**Avenal Power Center, LLC
500 Dallas Street, Level 31
Houston, TX 77002**

Ref: Response to California Energy Commission
Data Request Set 2 (# 75-94) for Avenal Energy (08-AFC-1)

**Avenal Energy AFC
(08-AFC-1)
Response to Data Requests 75-94**

EXHIBIT 79-1

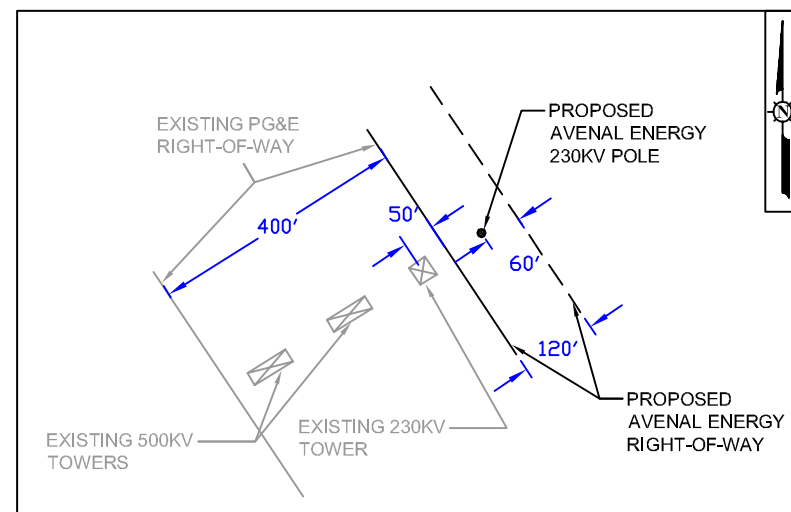
79. Please provide a drawing or photograph comparing the towers of the Tesla-Midway 230-kV transmission line towers, the newer 500-kV transmission line towers, and project's proposed new 230-kV transmission line monopoles, showing them to scale vertically and in their actual horizontal spatial relationship, looking north. Please indicate, also, the outer edges of the right-of-way (ROW).

PHOTO-DEPICTION OF THE NEW 230 kV TRANSMISSION LINE POLES

EXHIBIT 83-1
TRANSMISSION LINE
SURROUNDINGS
(REV. 9/16/08)

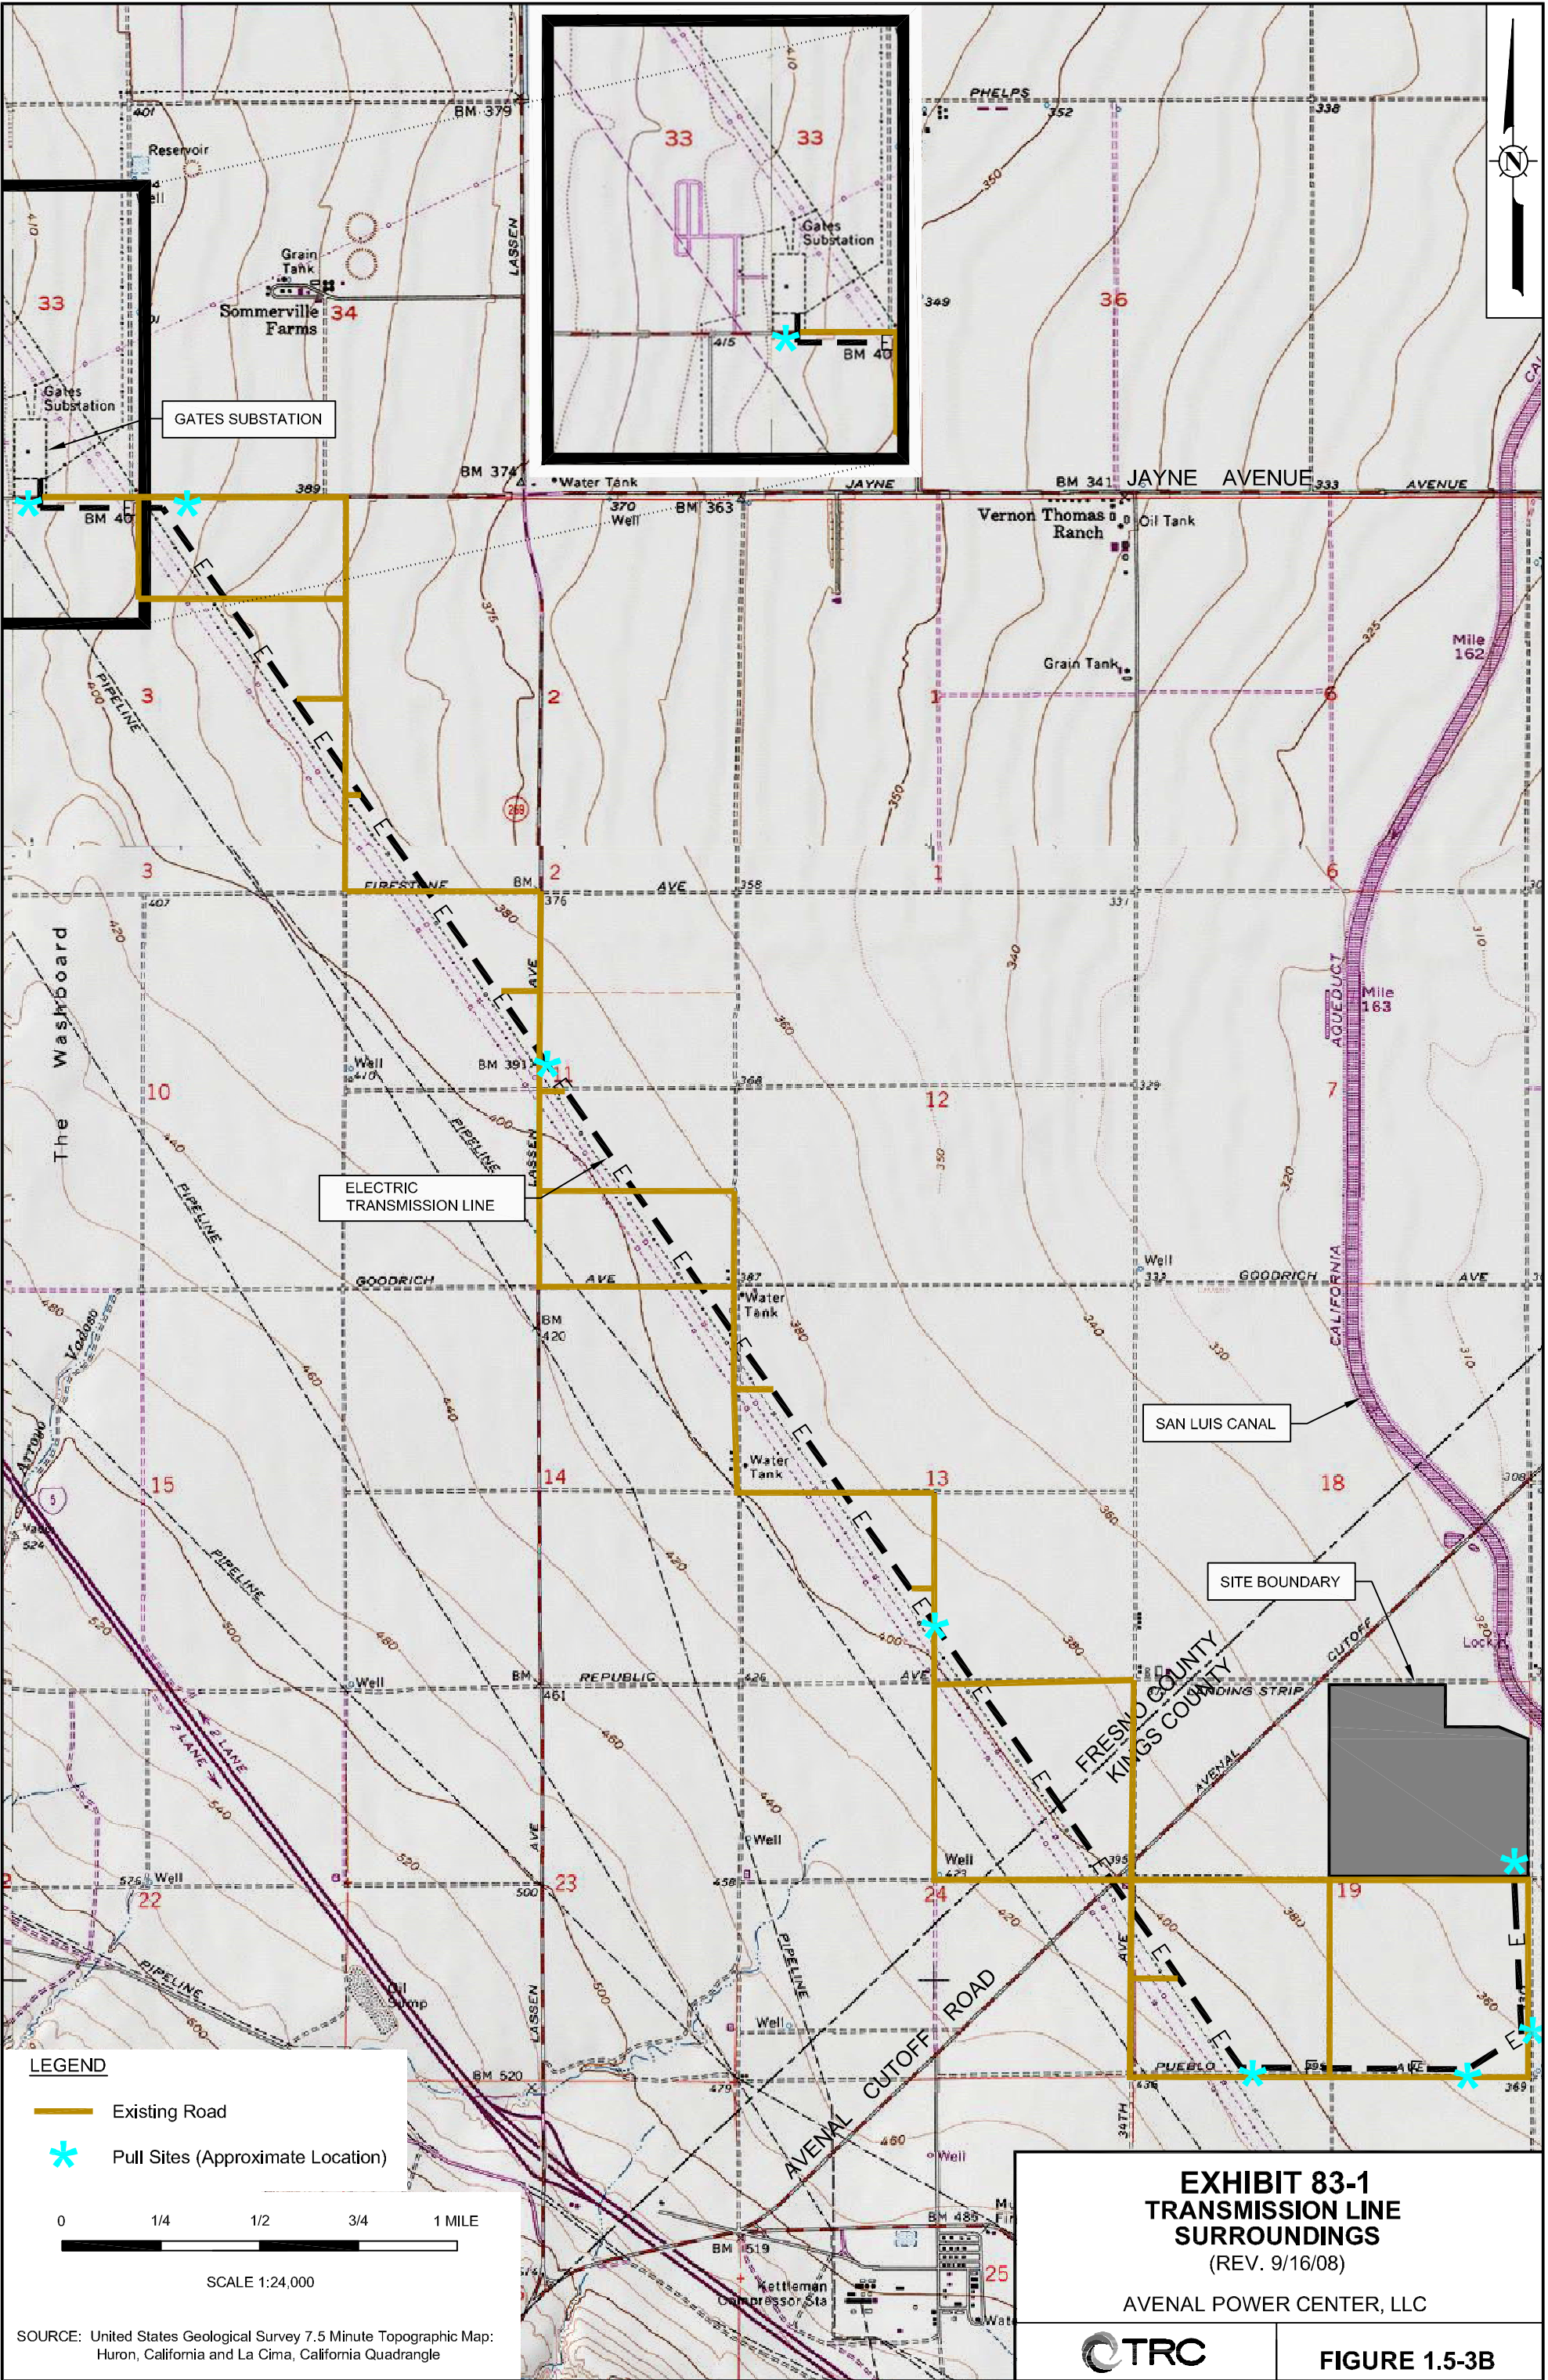
83.

- a. On a map, please show any existing access roads that are available for use in constructing the proposed new 230-kV transmission line.
- b. If no access roads are available for use in constructing the proposed new 230-kV transmission line, on the same map, please show the number and location of new access roads that would have to be cleared and graded, including new roads to each tower location, if any. Also, please provide an estimate of the extent of the area around the new roads where ground disturbance would occur as a result of the clearing and grading activities.

- c. On the same map, please provide the number and location of the pull sites that Avenal Power expects to use to install the conductors of the proposed new 230-kV transmission line. Also, please provide an estimate of the extent of the area around the pull sites where ground disturbance would occur as a result of the installation activities.

EXHIBIT 83-3
UPDATED AFC FIGURE 2.3-12

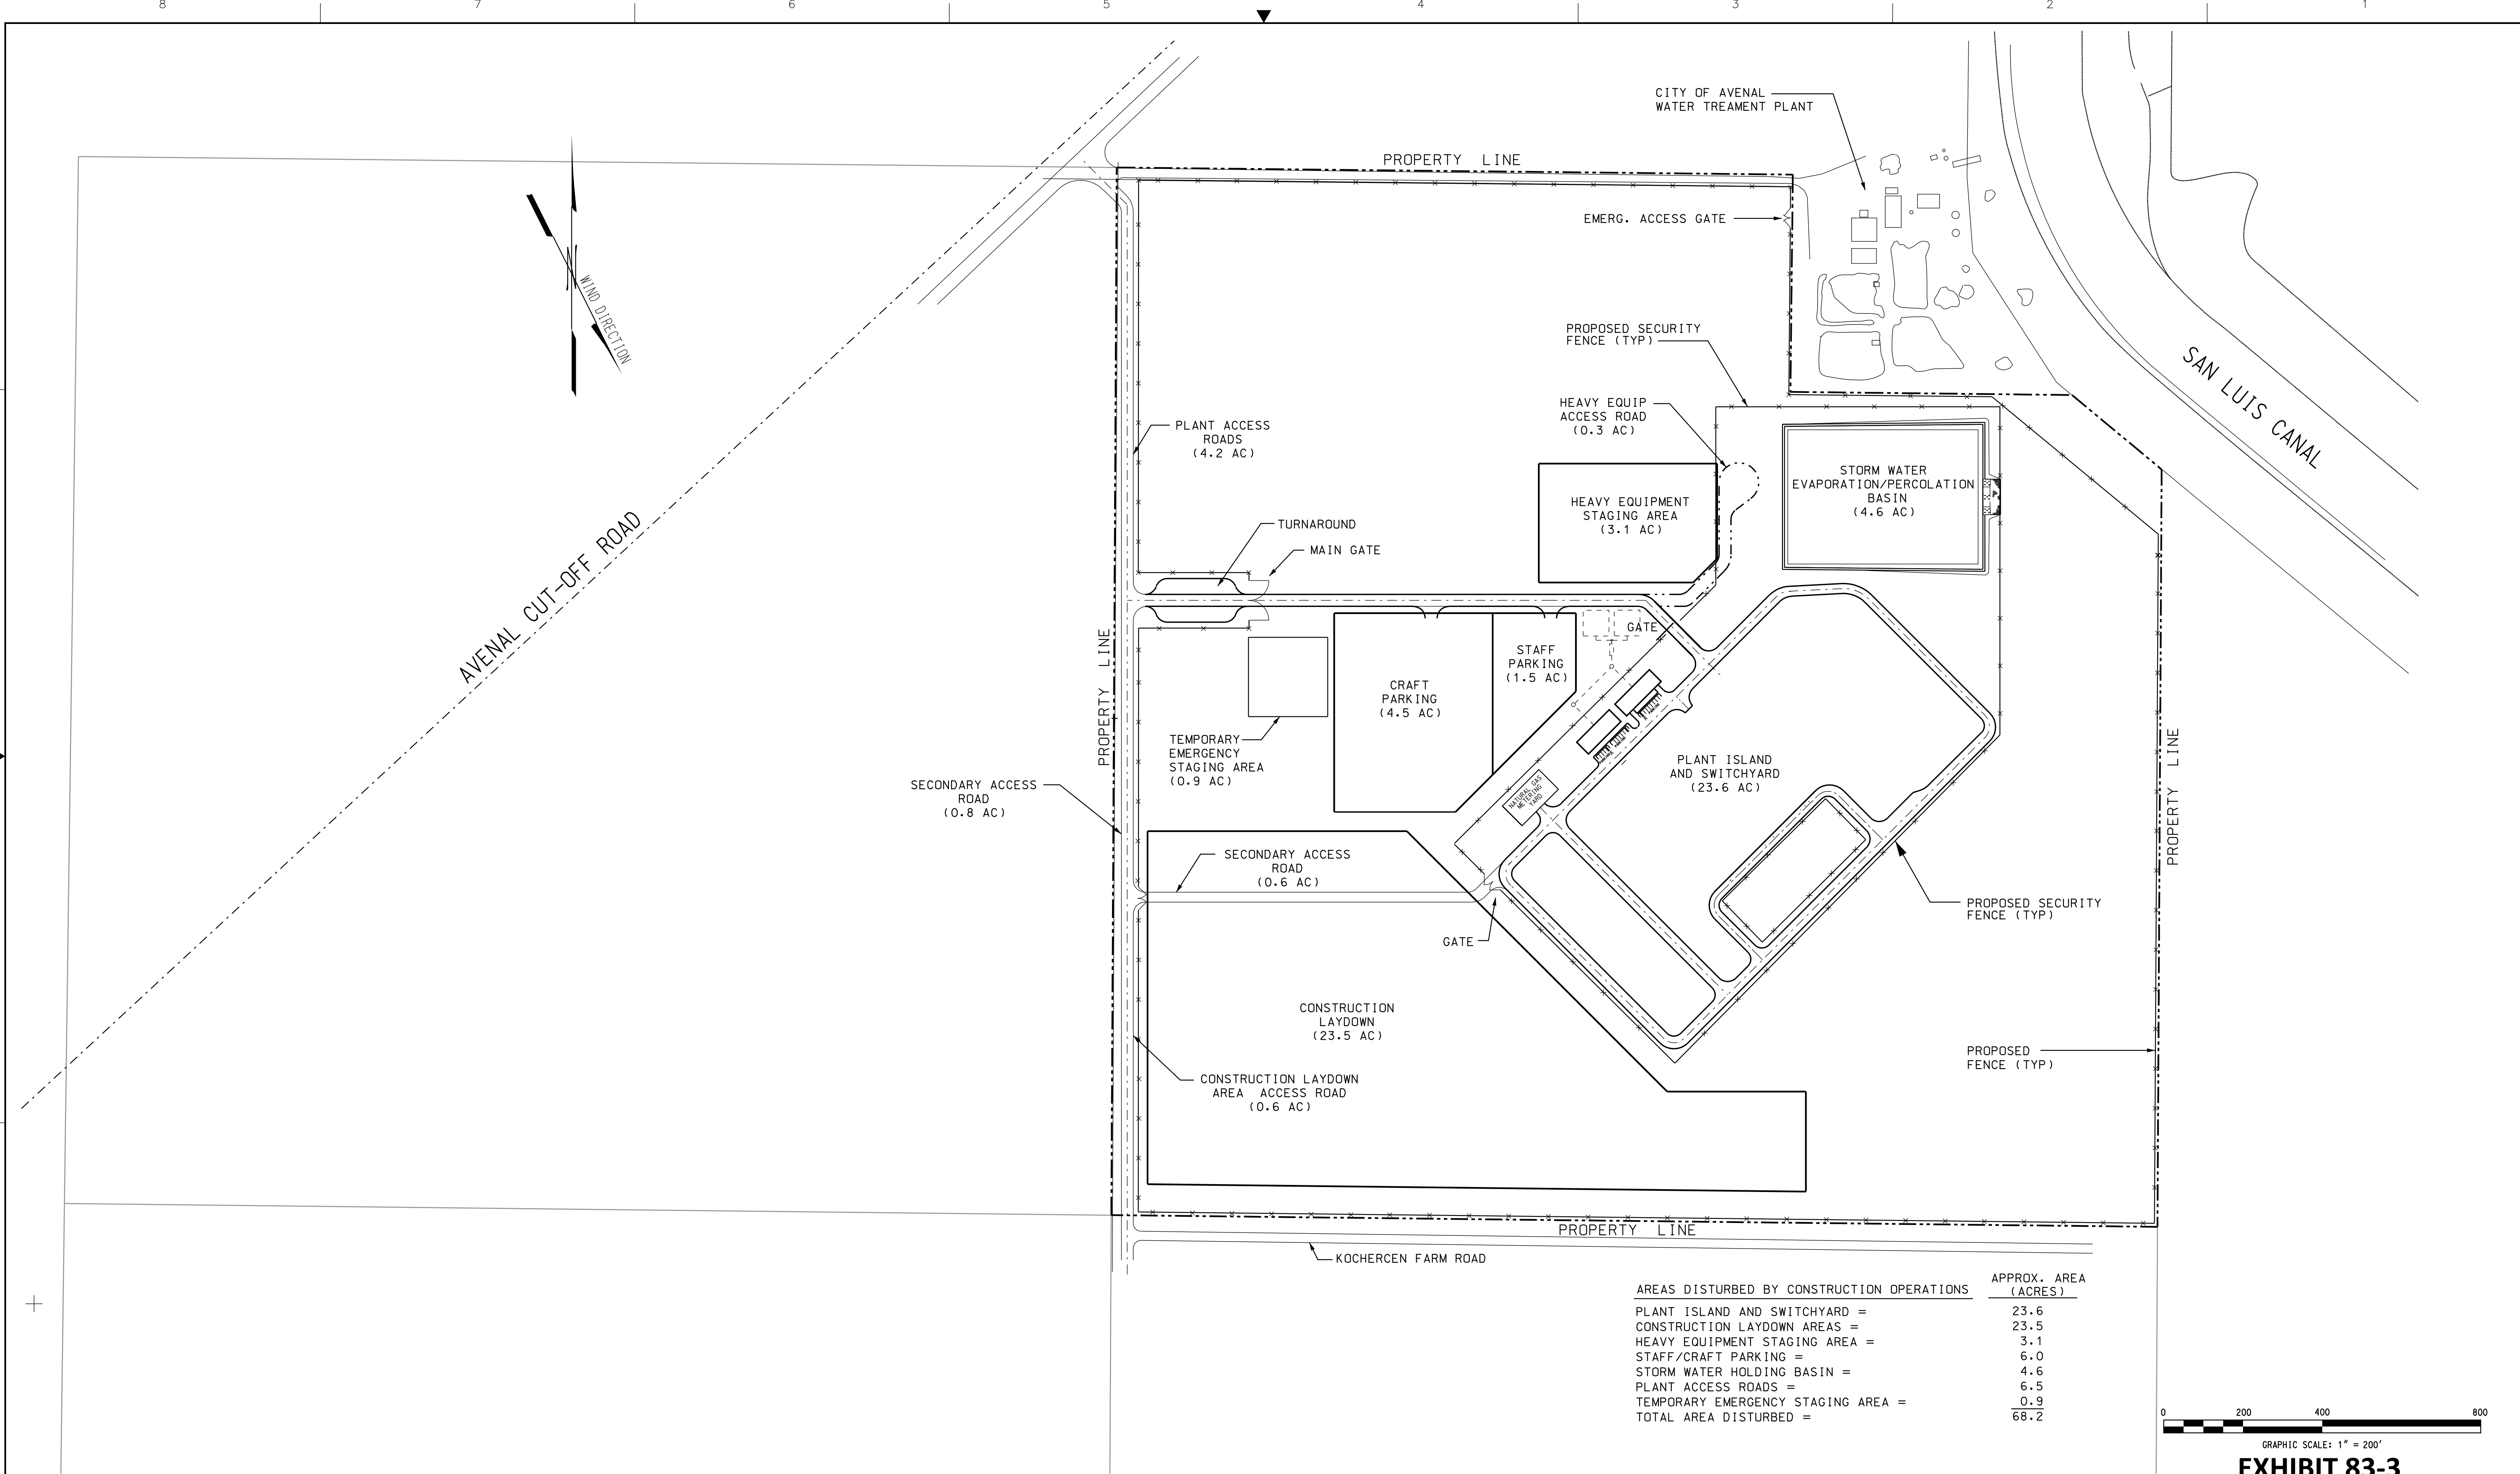
To confirm the temporary and permanent disturbances associated with minor changes requested by the CEC and other agencies, the Applicant has updated the site layout shown in AFC Figure 2.3-12 showing temporary construction disturbance. The updated Figure 2.3-12 is provided in Exhibit 83-3. The updated Table 2.3-7 in Exhibit 83-2 reflects the updated layout. The updated layout includes a new temporary emergency staging area that the Applicant has added at the suggestion of the Kings County Fire Marshall for use by City and County emergency response teams, if needed, during construction. This emergency staging area will only be a disturbance during construction. All disturbance areas have been conservatively estimated (i.e., maximum potential disturbance numbers have been used).

EXHIBIT 92-1
POTABLE WATER LINE ROUTE

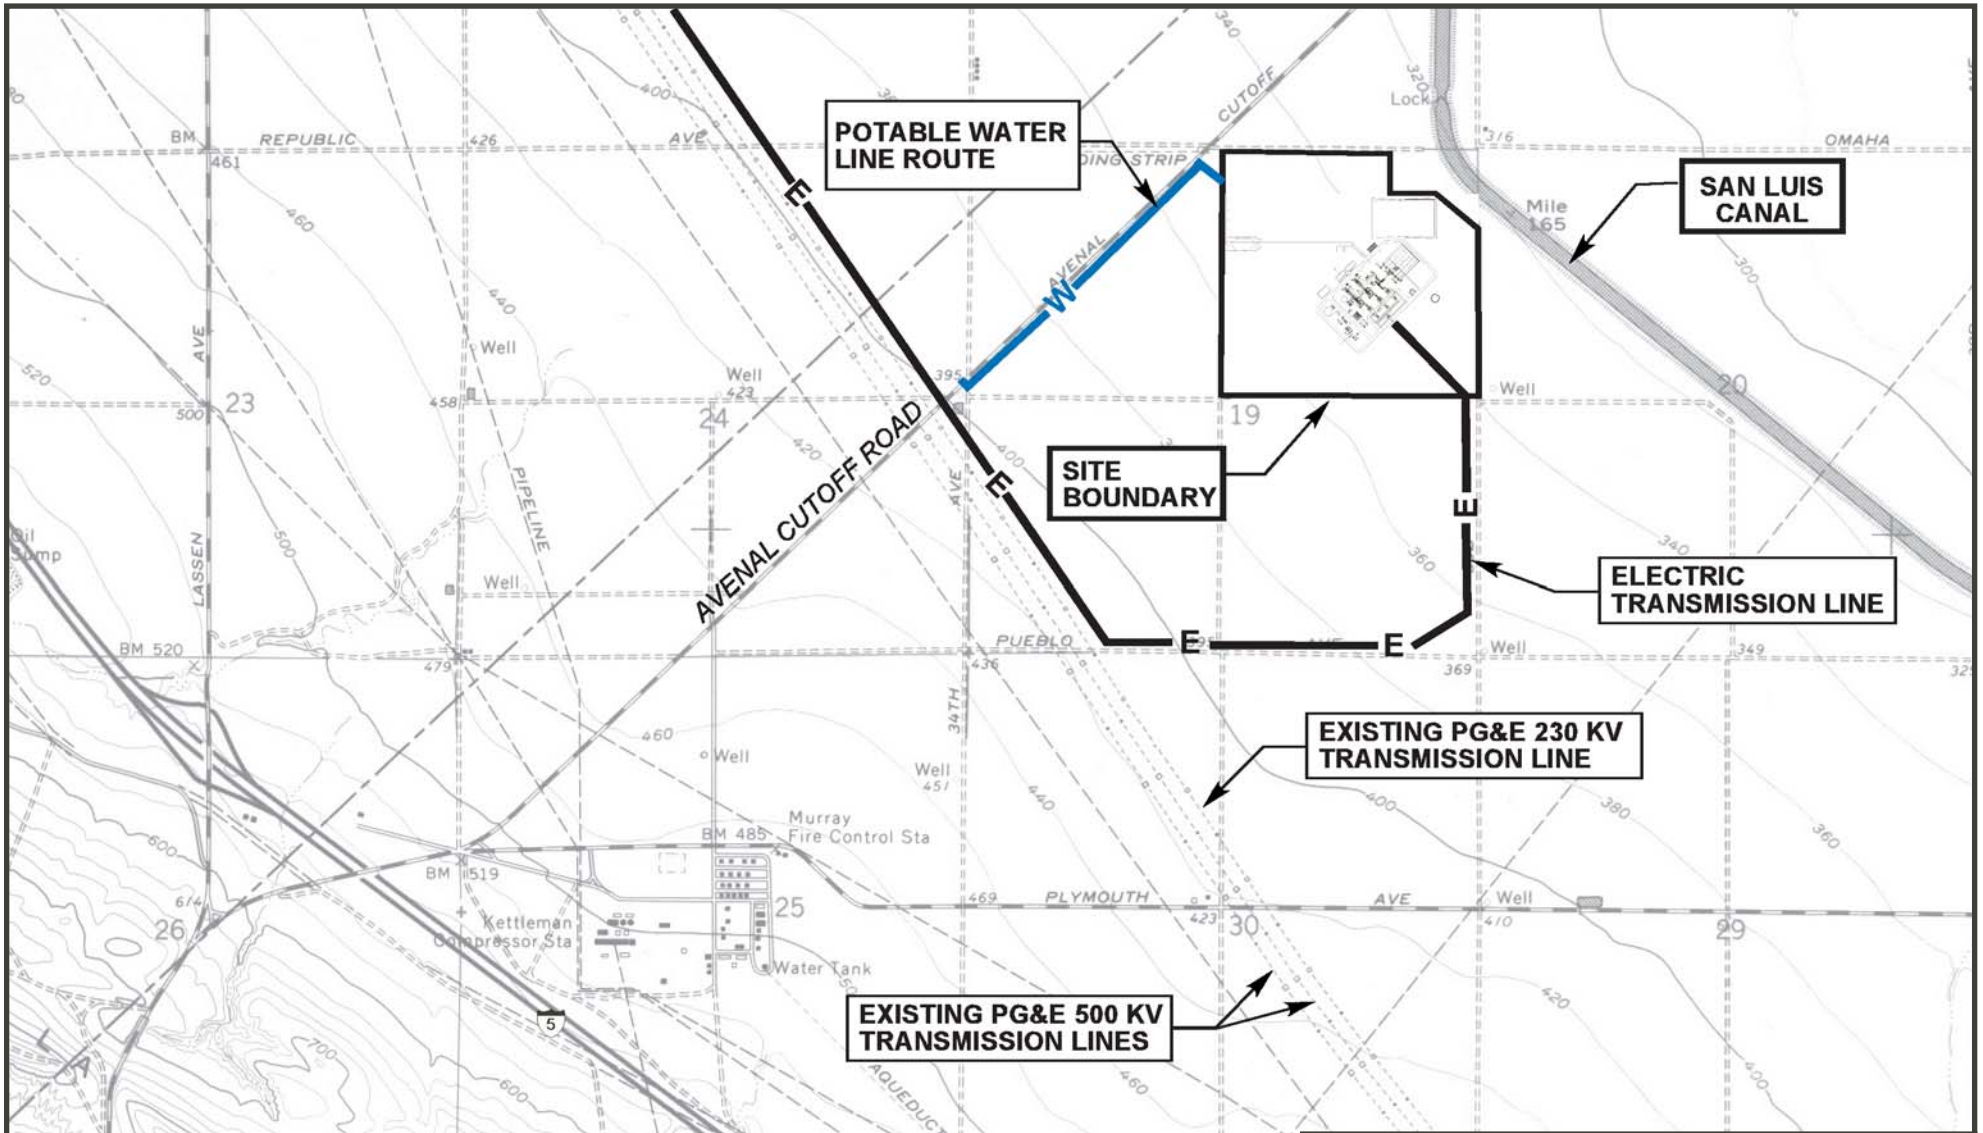
93. Please provide documentation that the Administrative Authority has concluded that it is not necessary to provide an adequate supply of potable running water throughout the facility.

The Applicant will interconnect with the City of Avenal's potable water system; therefore, an adequate supply of potable running water will be provided throughout the facility. Exhibit 93-1 is a will serve letter from the City of Avenal agreeing to provide potable water for the Project and reiterating its ability to provide a total amount of water equivalent to 200 AFY.
